AIA[®] Document G716[™] – 2004

Request for Information (“RFI”)

Harrison, Town-Village Recreation Center Phase 2
270 Harrison Avenue
Harrison, NY 10528

RFI No. 32

S102

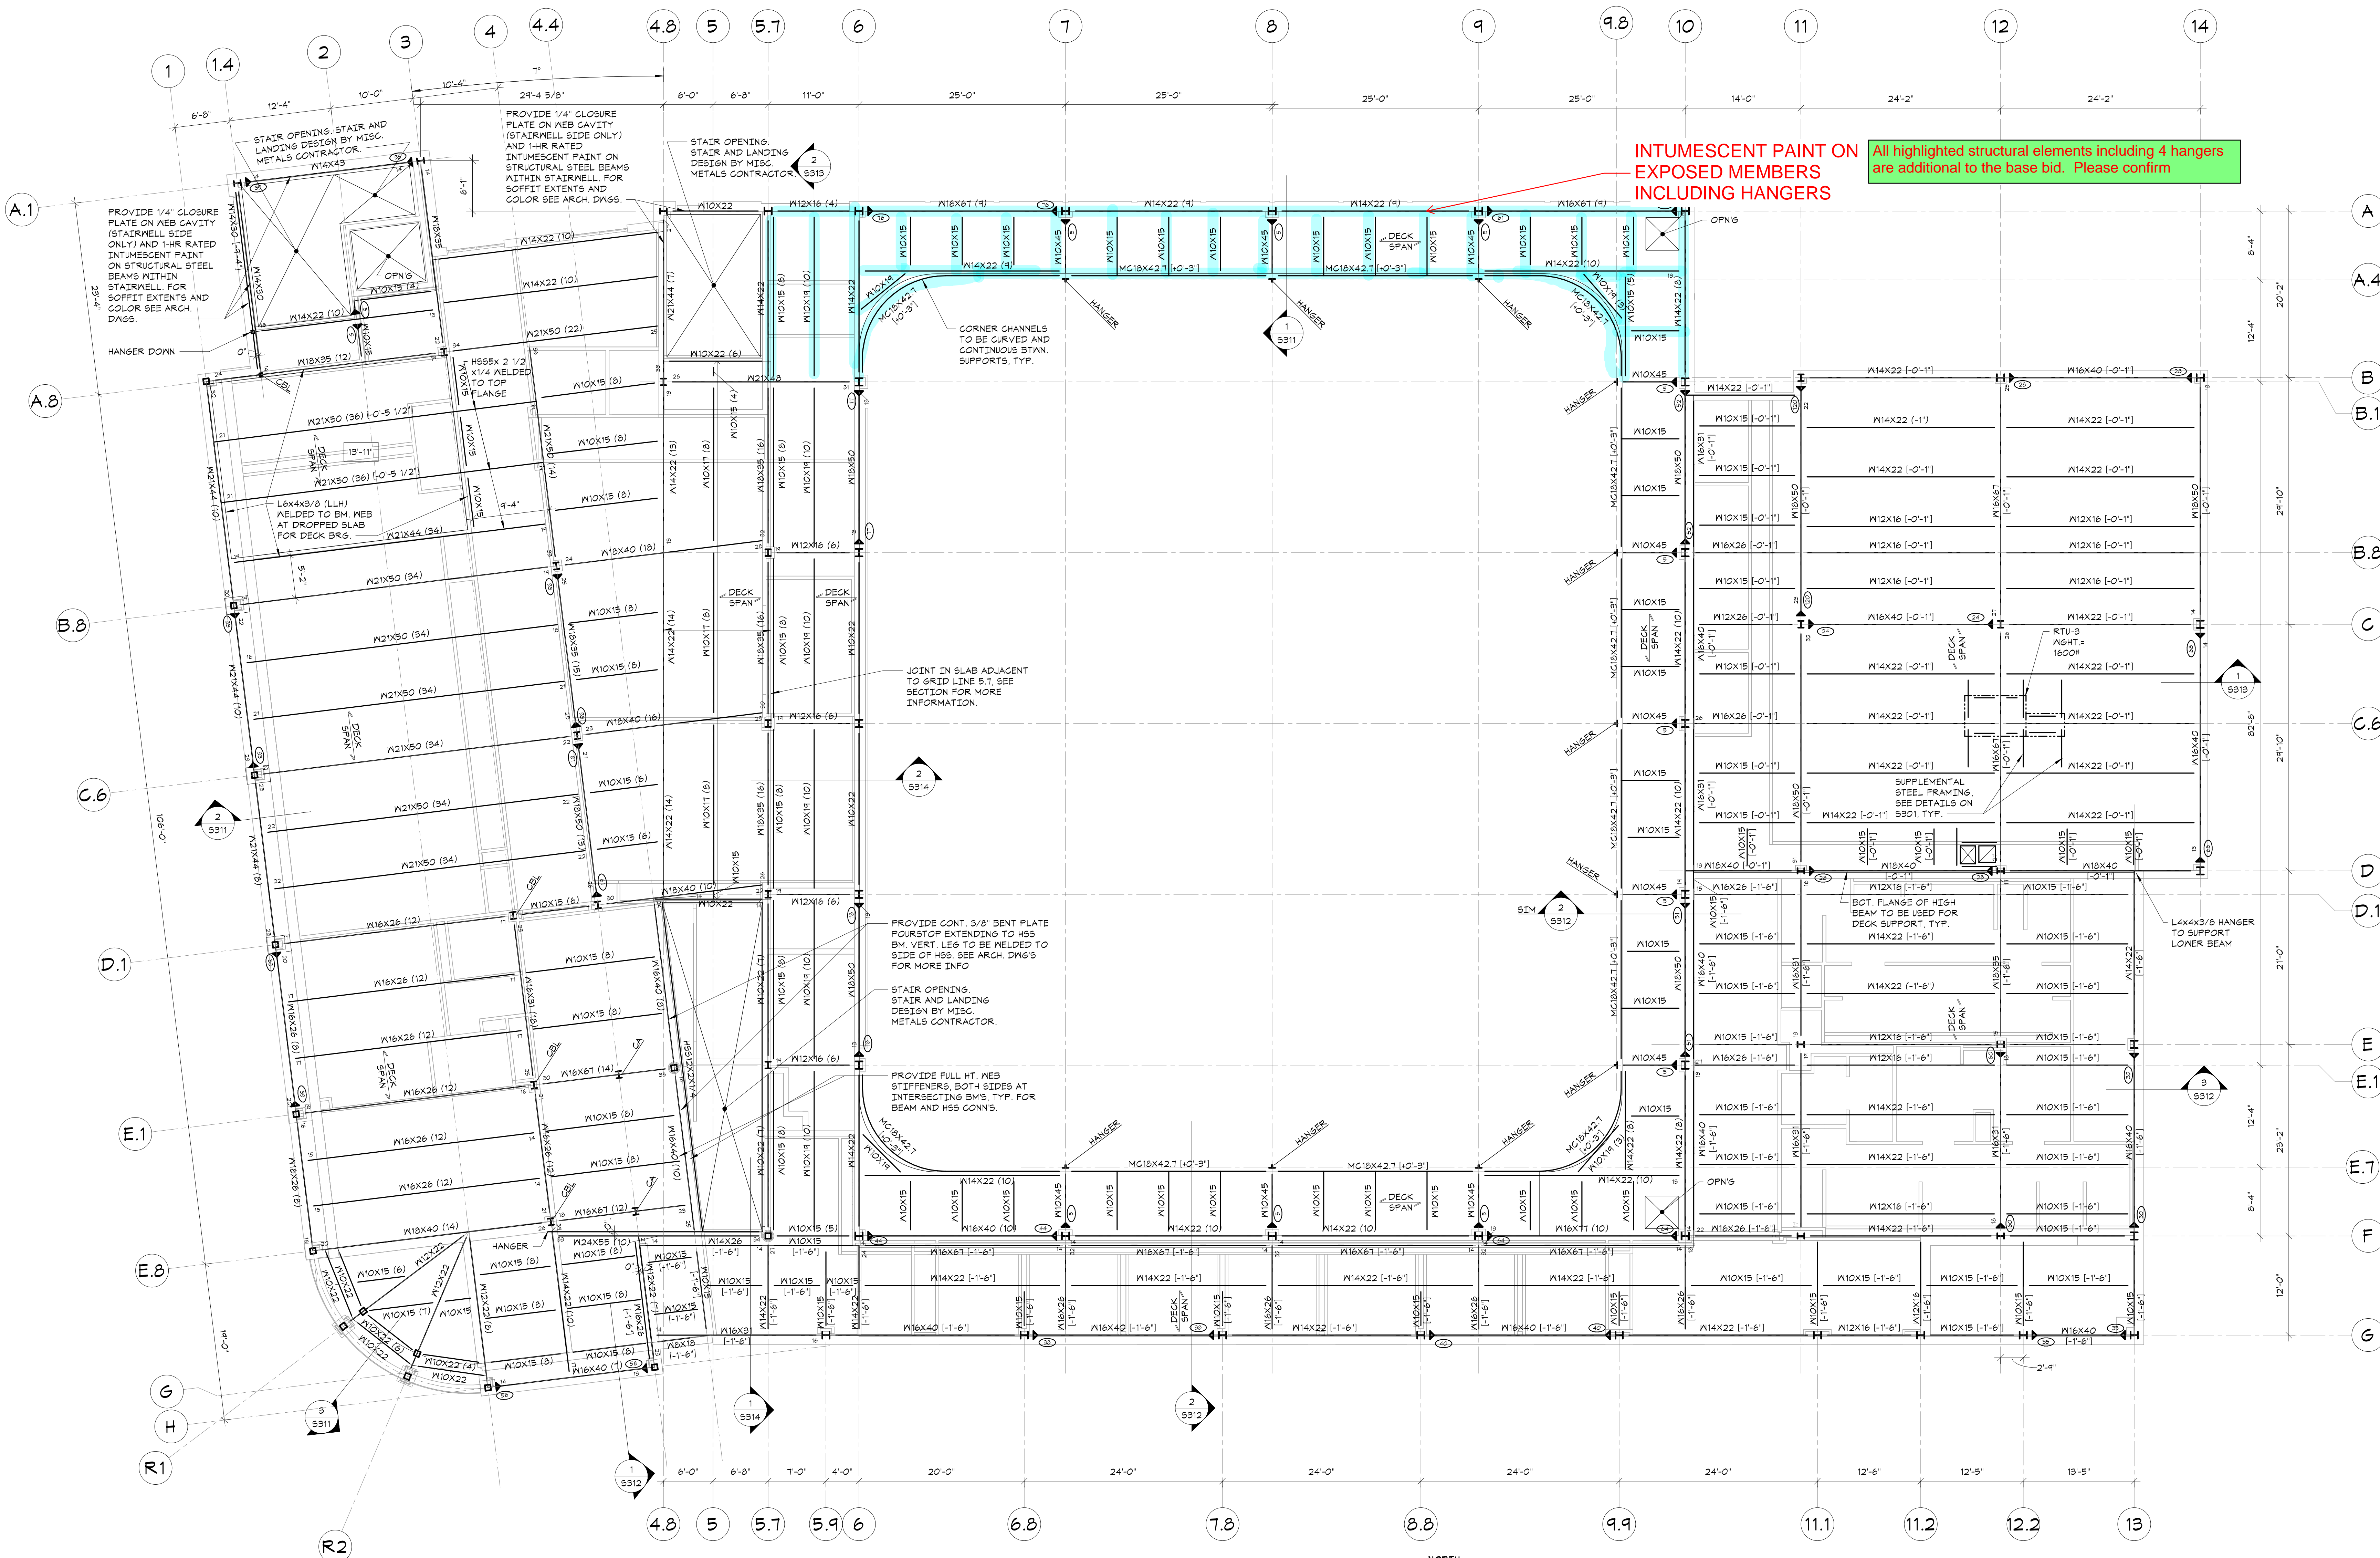
On reference to bid addendum #4, question #61: Drawing CC001 establish the building as type IIB: 0 hrs fire resistant for building elements; if fireproofing is necessary at the gymnasium please clarify the extension of the intumescent paint (trusses and beams?); another issue to consider is the roof deck, without any concrete on it, the deck itself will need to be rated for 1 hour as well as the beams.; there is not a UL design that supports the deck achieving a fire rating with intumescent paint. Please advise.

SEE ATTACHED STRUCTURAL PLANS INDICATING THE EXTENTS OF THE INTUMESCENT PAINT AT THE GYM. AS THE ROOF FRAMING IN ITS ENTIRETY EXCEEDS 20' ABOVE THE FLOOR THE ROOF ASSEMBLY IS NOT REQUIRED TO BE RATED.

S103

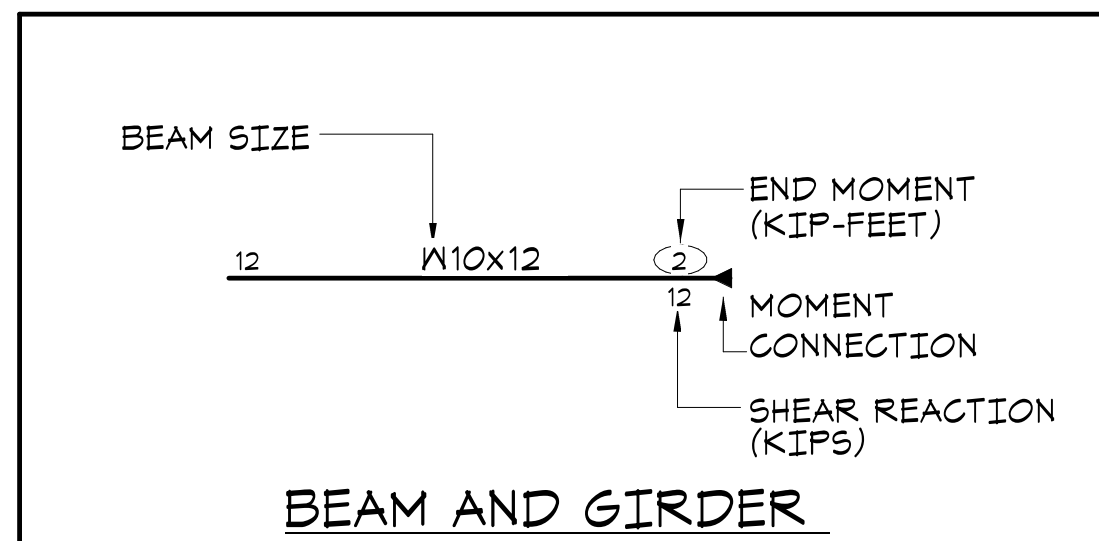
Per statement above, at the roof assembly: no fireproofing should be included, only intumescent paint is required . Please confirm.

Drawing S103, Roof Framing plan: Only structural members from line 6 to line 10 along column line A required intumescent paint, no other members are included in base bid, perpendicular items is additional if required, please advise.

Please confirm if intumescent paint is required on all
perpendicular items within the gym roof, from line A to B.1.

CORRECT- ONLY MEMBERS WITHIN 10 FEET OF COLUMN LINE A AND AS SHOWN ON PREVIOUS RFI RESPONSE RECEIVE INTUMESCENT COATING. INTUMESCENT REQUIRED HERE DUE TO SETBACK DIMENSION TO THE NEIGHBOR'S PROPERTY AND IS REQUIRED BY TVH

SEE 4/A802- PERPENDICULAR MEMBERS ARE INCLUDED.

10' REQUIRED BY
AHJ

EXTENT OF
INTUMESCENT
PAINT PER
ADDENDUM

CONFIRMED

INTUMESCENT NOT
REQUIRED ON TRUSS
